HPSII Phosphate Mine

Alachua County Concerns

SW Pre- and Post-mining Mine Wide Basin Modeling

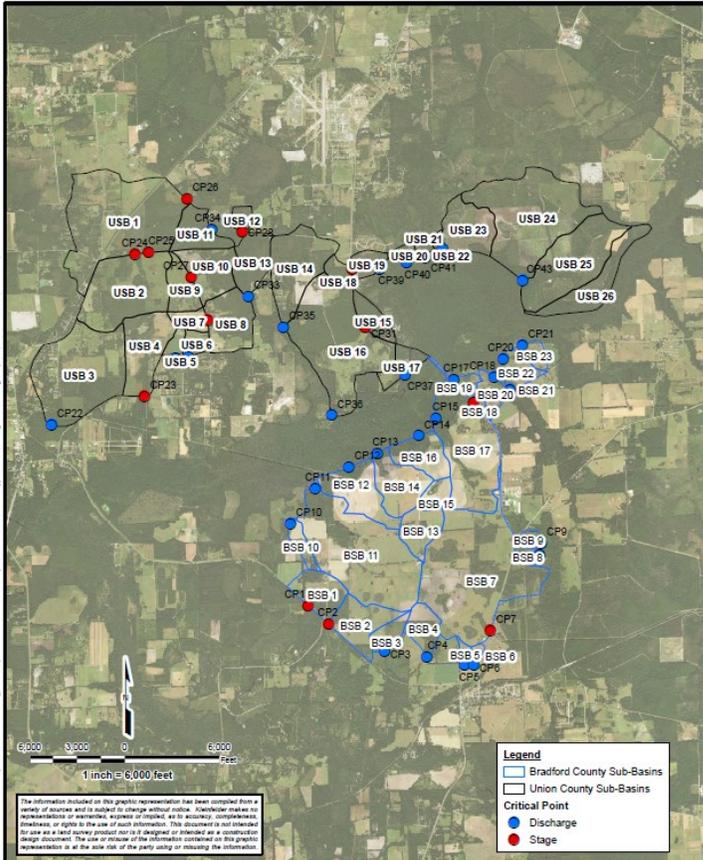
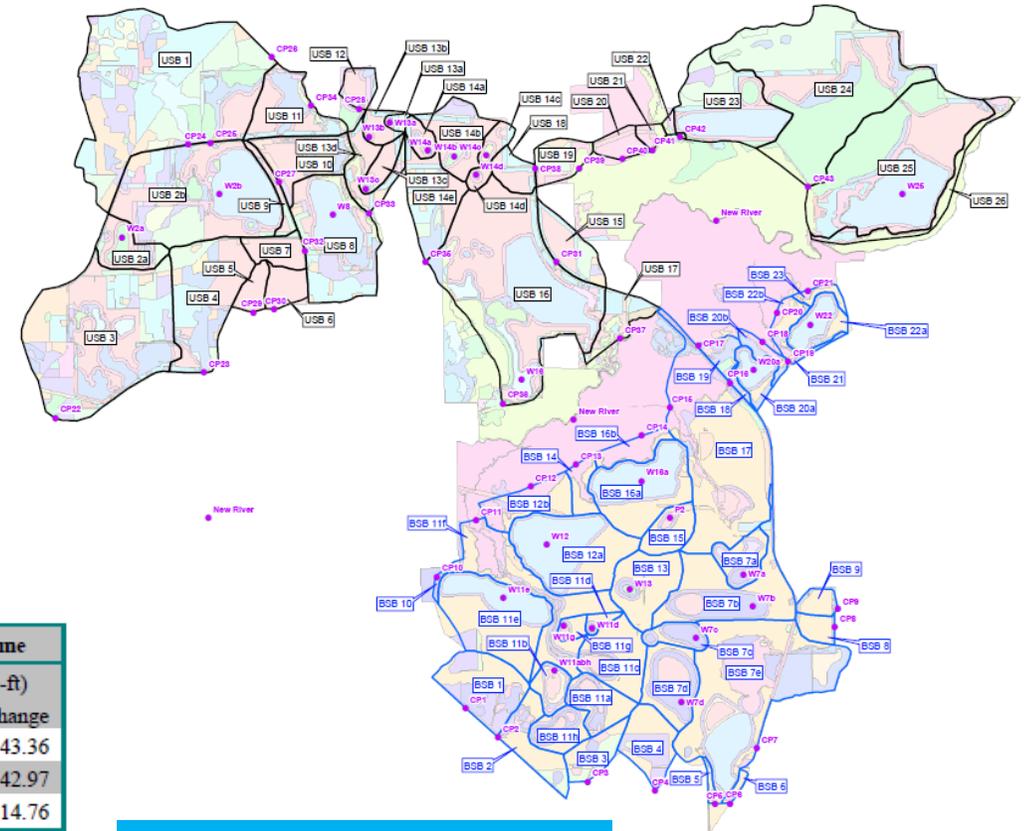
- SW modeling was event based
- Continuous model is required to evaluate impacts to the MFL

Figure 1. Annotated Topographic Map with Stream Gage Stations

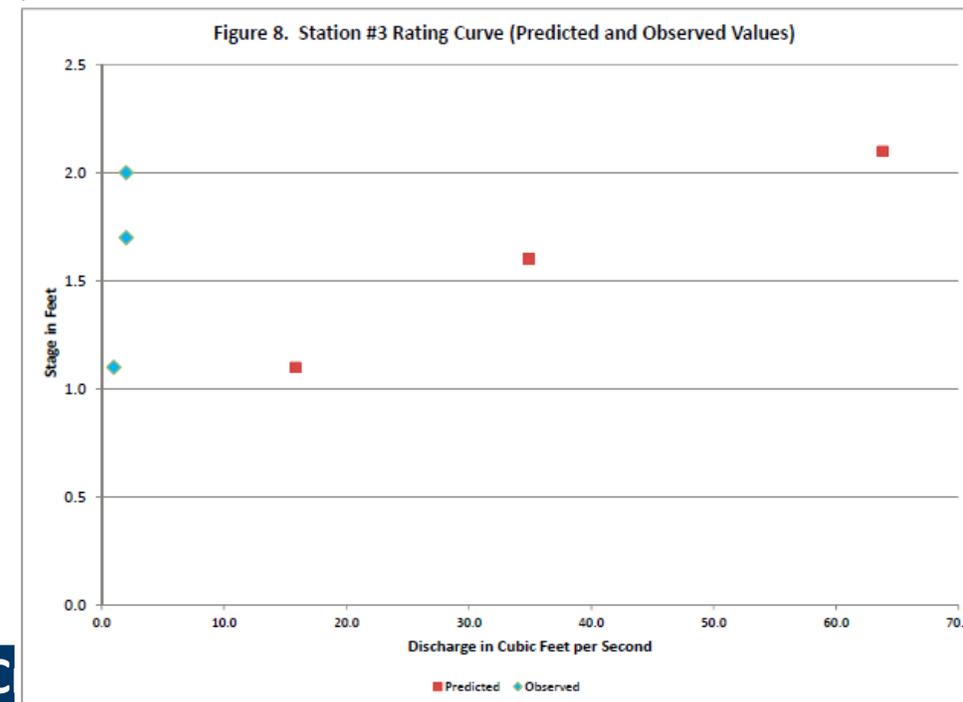
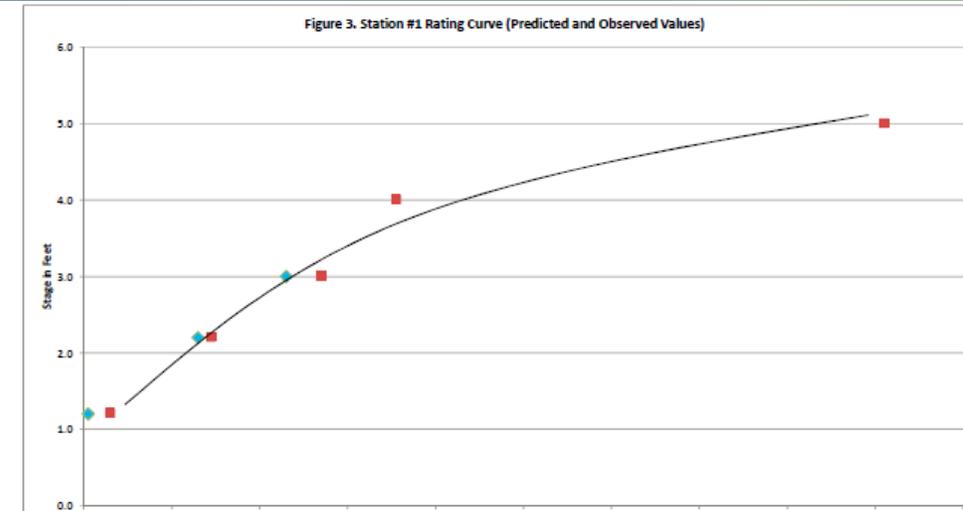
- Stage/Discharge relationship should not be changing since river and riparian area are not directly impacted
- Point calibration does not account for shoaling present throughout the system, Figure 8
- Spreadsheet models are poorly constrained at high flows
- Does not address the impacts to flow from changes in land use/land cover

Figure 1 Water Balance Modeling Overview

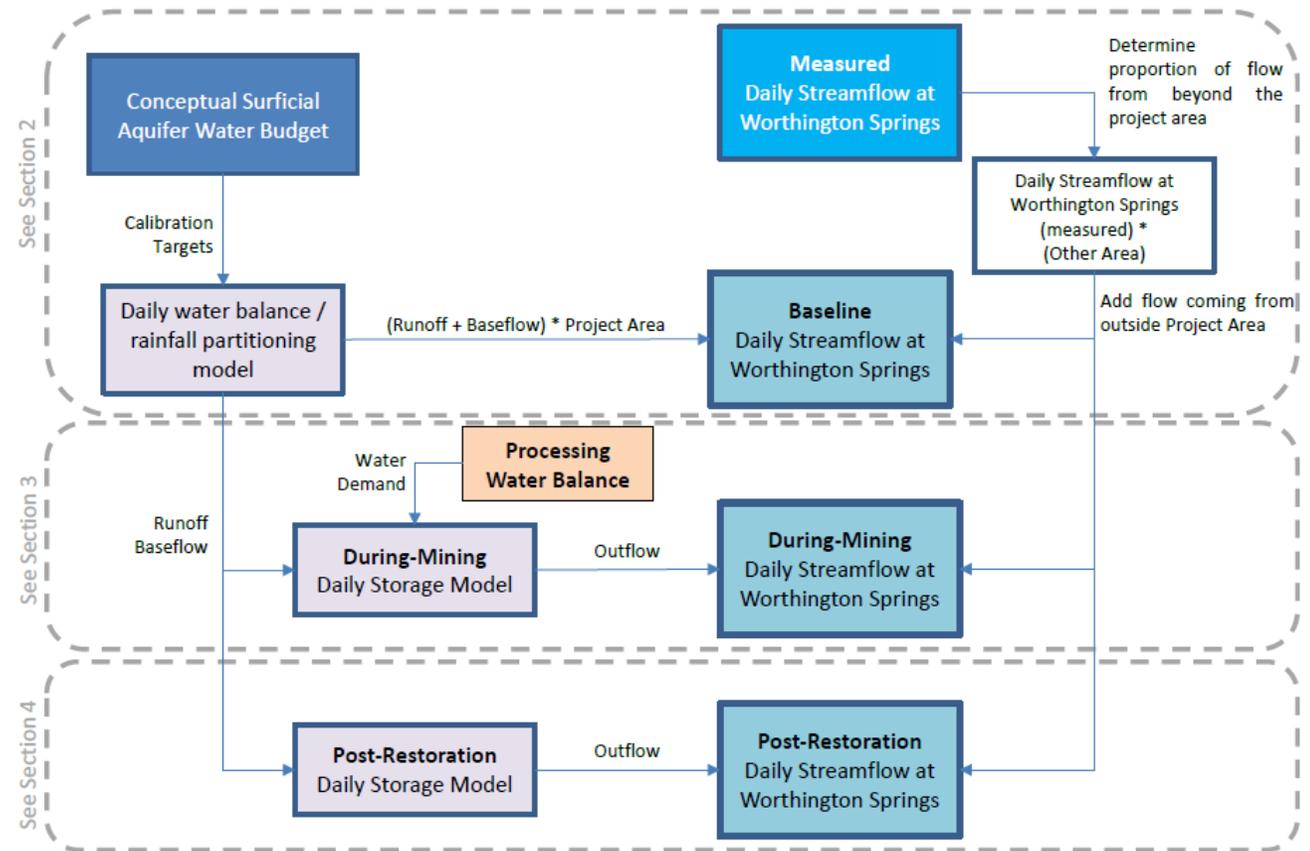
- Complex water balance deals mostly with process water within mine operations
- Stormwater capture/recovery accounts for over 50% of the proposed mine water needs, this supply will reduce low flows in the New River
- Does not address land use/land cover changes and associated impacts to the basins hydrologic response

**Post-Restoration Water Table
Percent Exceedance**

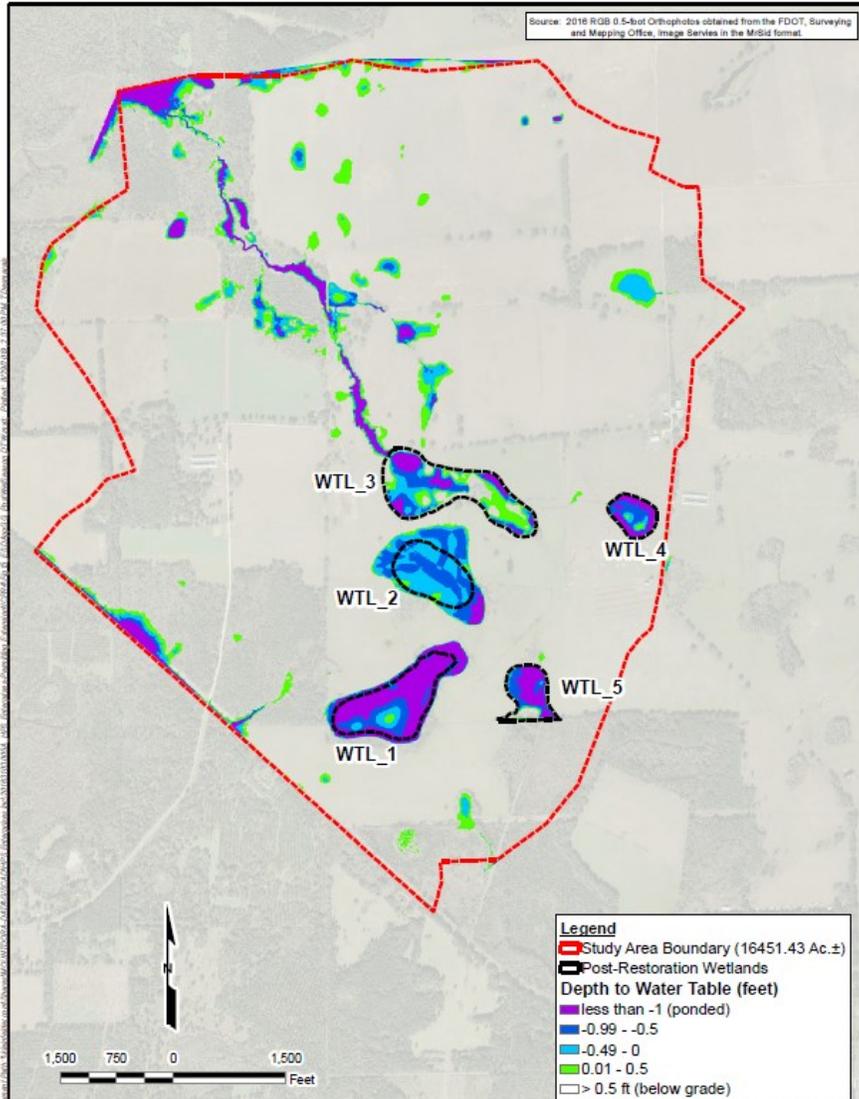
- ICPR4 model is not mine wide
- No surface water calibration, therefore uncertainties exist in the predictive capability of surface water model and water balance
- Post-reclamation parameterization is not founded with observed sand clay properties
- Water balance addresses process water but not land use changes and consequent changes to hydrologic response

Pre- Post- Land Cover

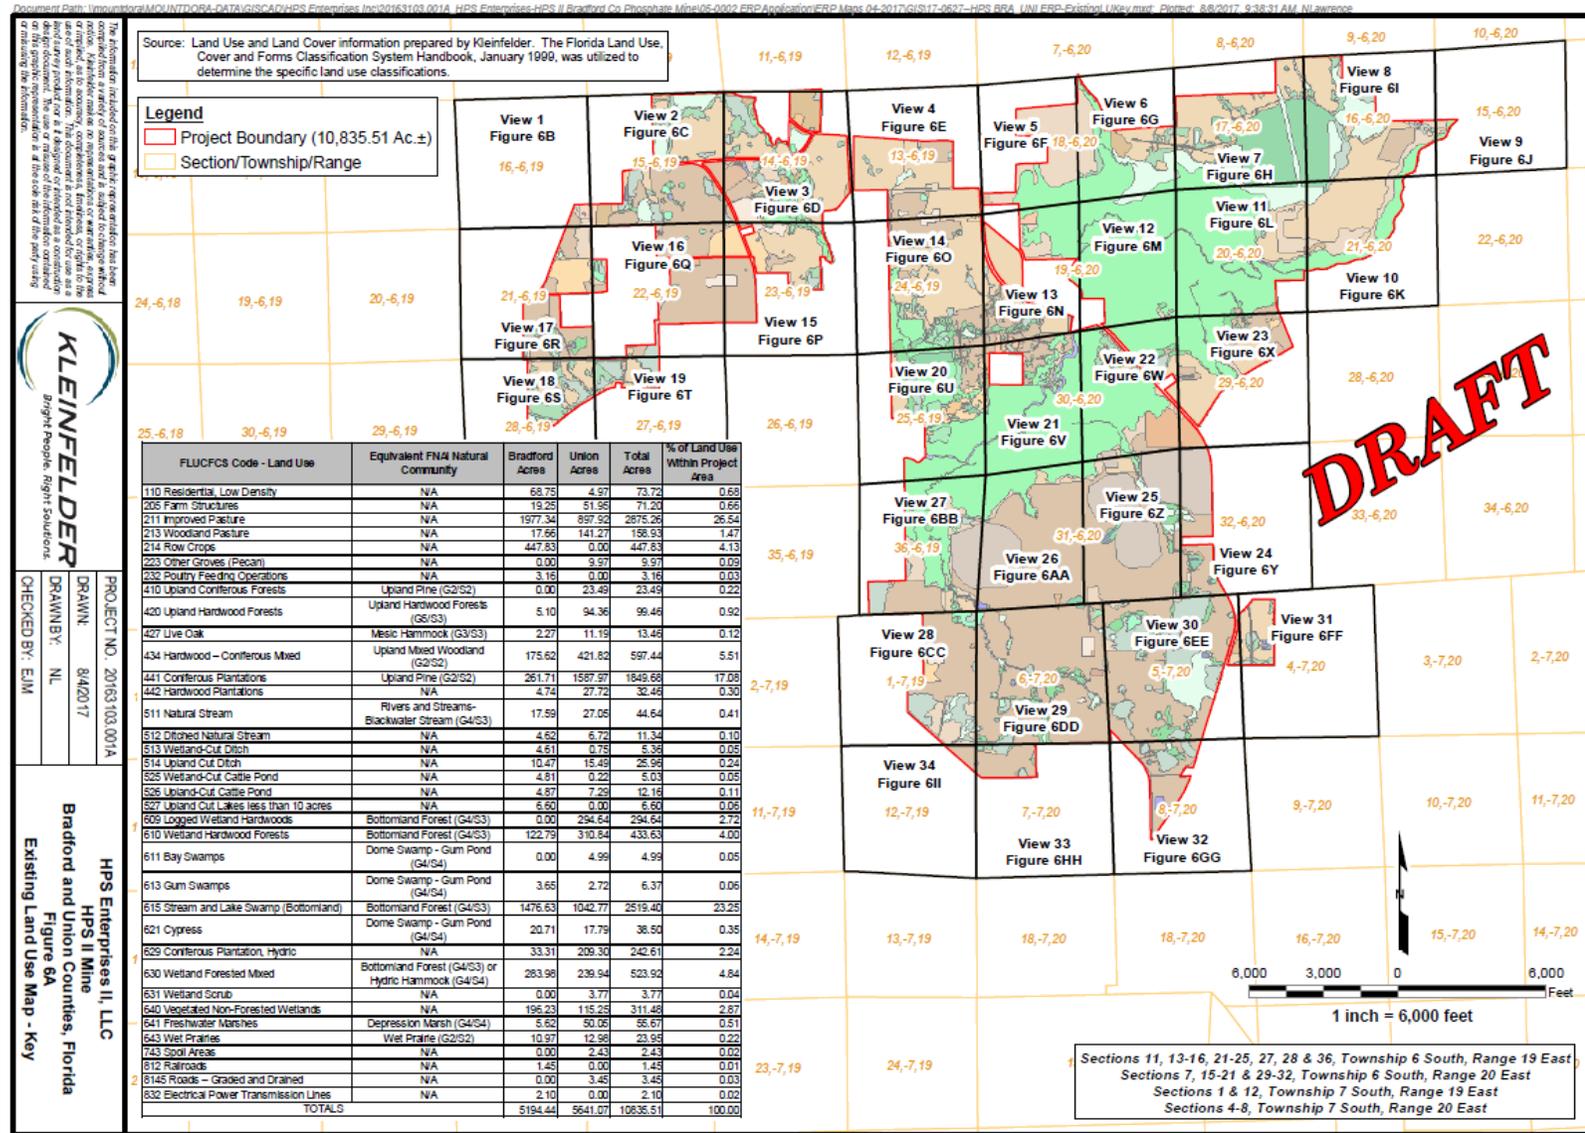
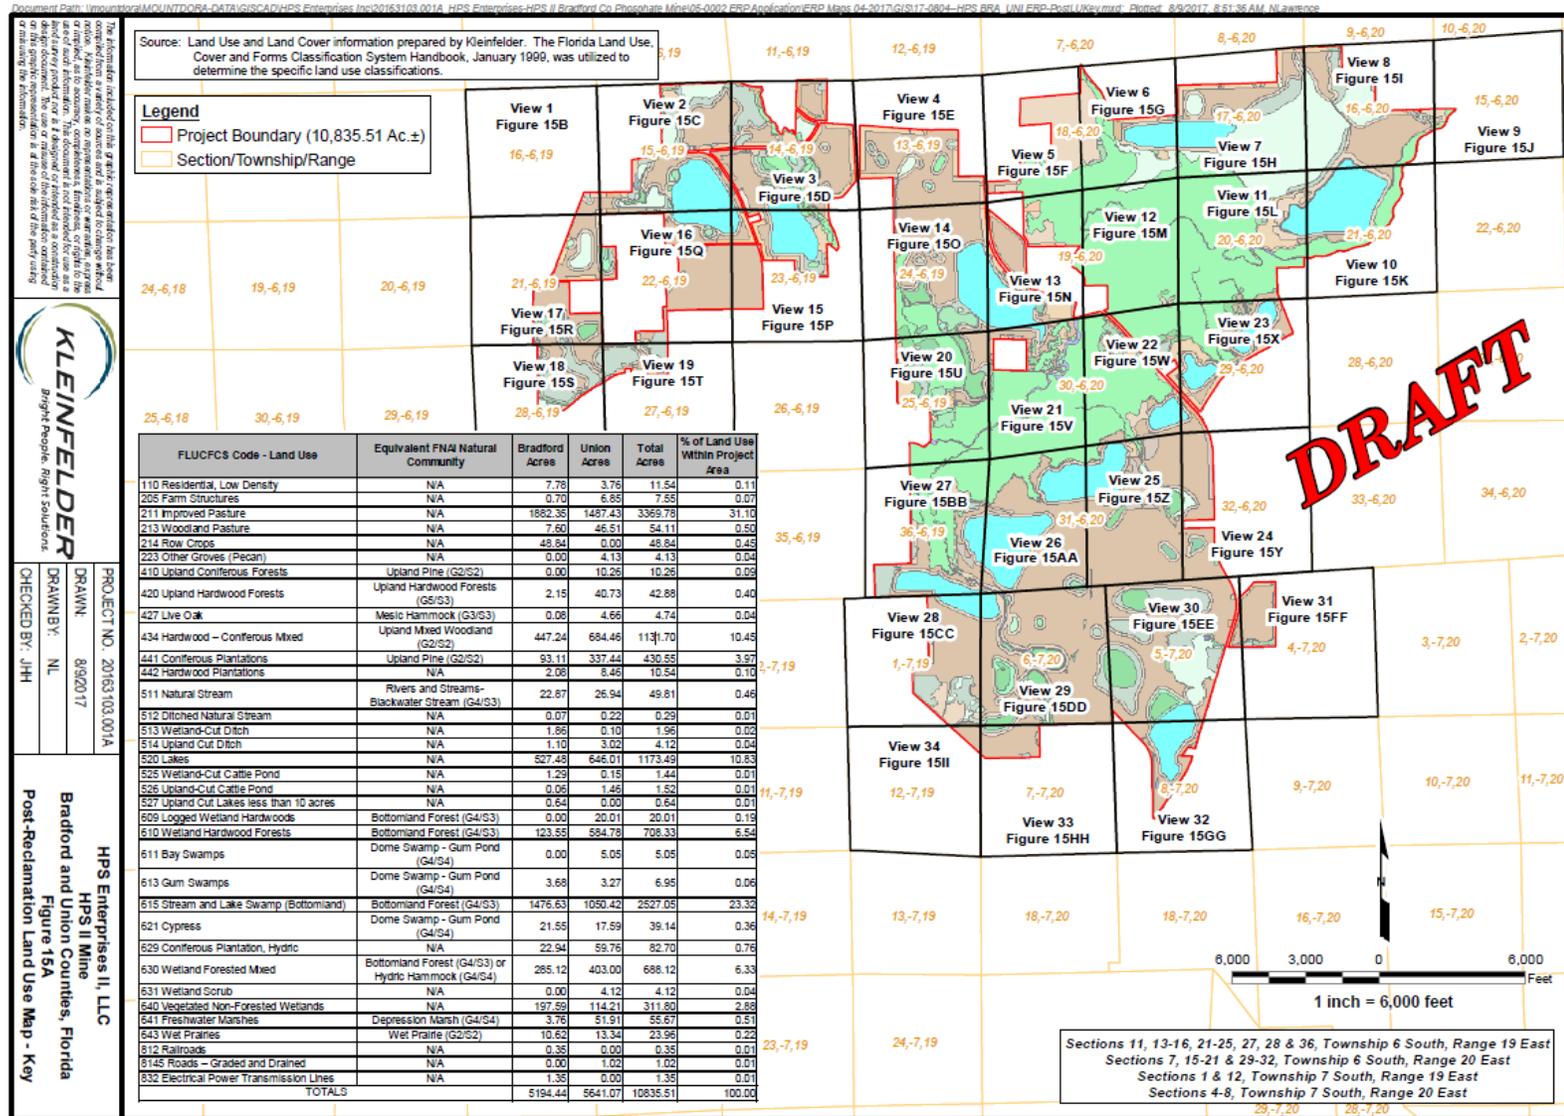
- About 2 square miles of lakes will be created as part of the reclamation plan
- Lakes evaporate at or near Potential ET rates, **dramatically** reducing the water that could leave the site
- Event based modeling ignores ET losses, continuous modeling captures impacts from changing land use

- Note the large lake areas in the reclamation plan

Ground Water – MODFLOW Model

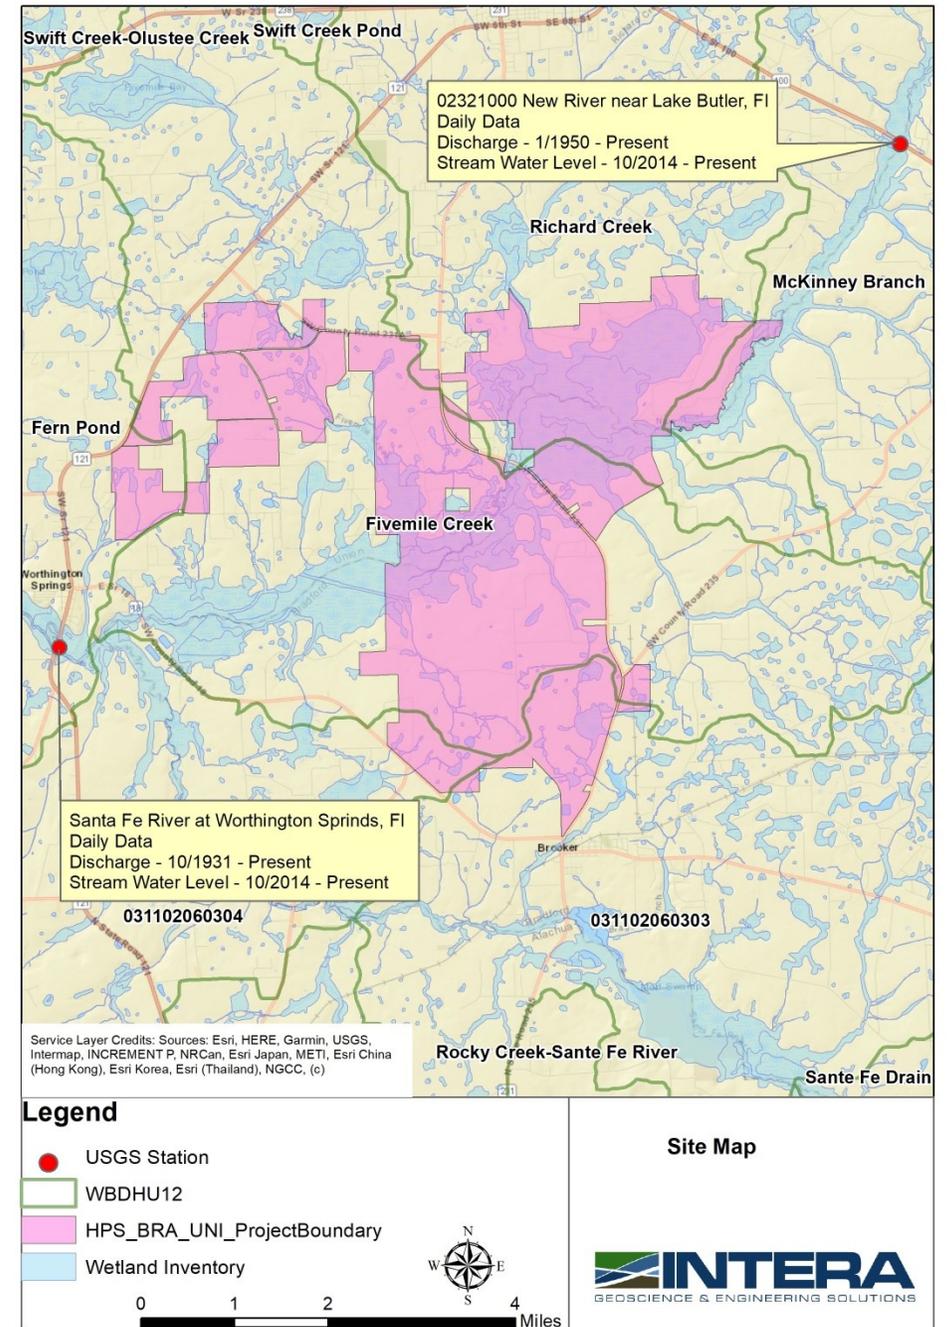
- Develop **Mine wide GW model**
 - Appropriate boundary conditions
 - Incorporate active mine (dewatering)
 - Incorporate reclaimed mine
 - At least incorporate surficial, intermediate and Floridan layers
- Proposed consumptive use and water level changes
 - How will mine water consumption and water level changes affect Upper Santa Fe MFL
- Hydraulic properties (pre/post)
- GW model should be based on NFSEG (model co-developed by SRWMD and SJRWMD to evaluate MFLs)

Conveyor Crossing Plan

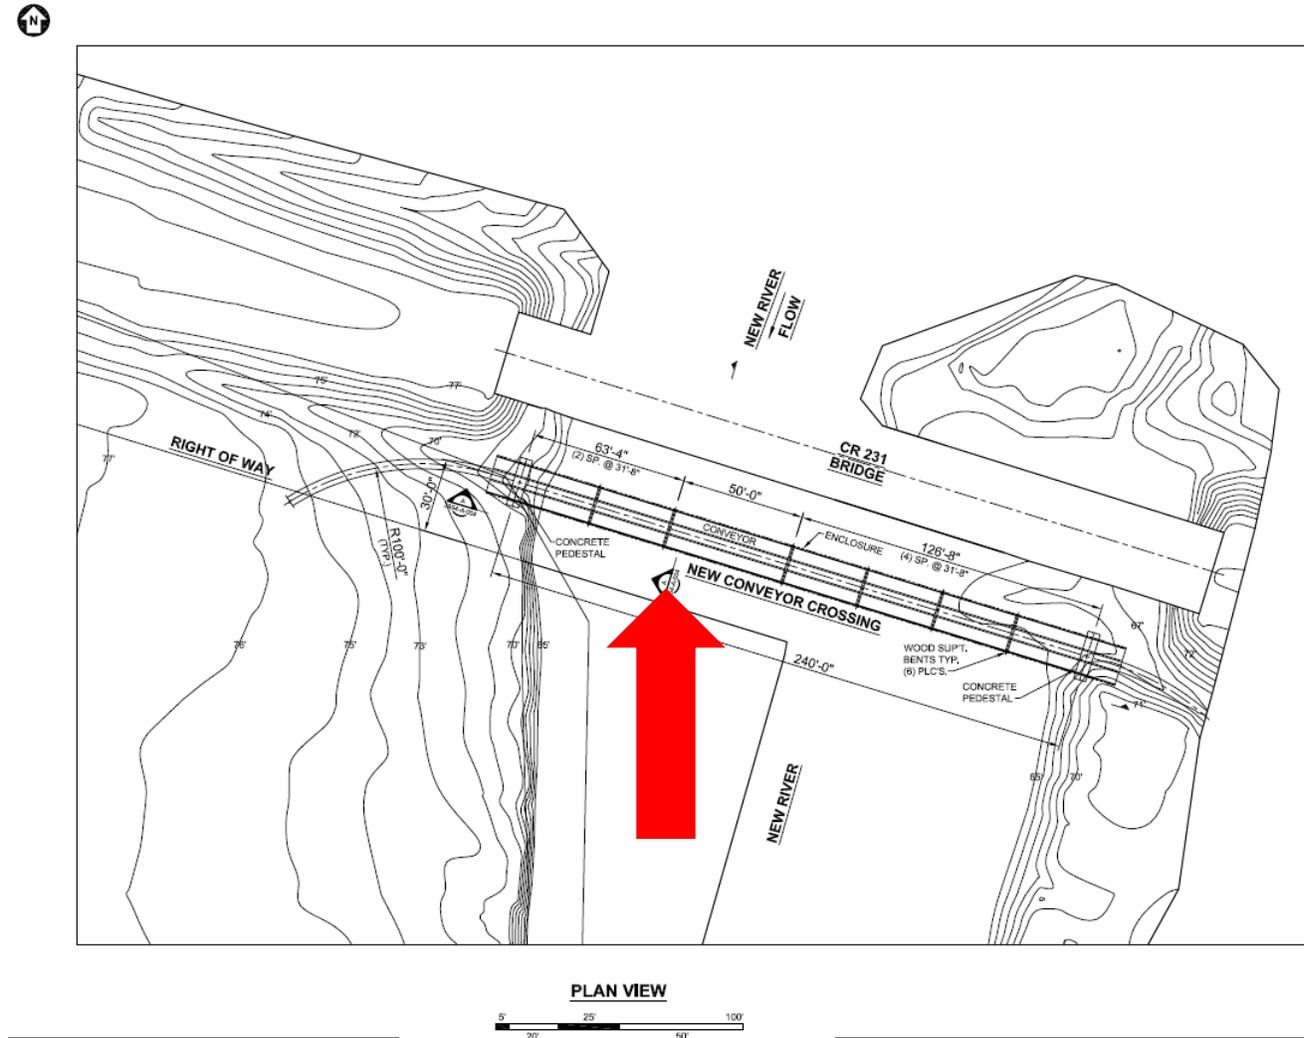
- Hydraulic impacts at river crossing
- The many piers in the channel will cause additional erosion
- The conveyor crossing is extended towards an area where the principle axis of the river more north-south
- Additional debris accumulation possible
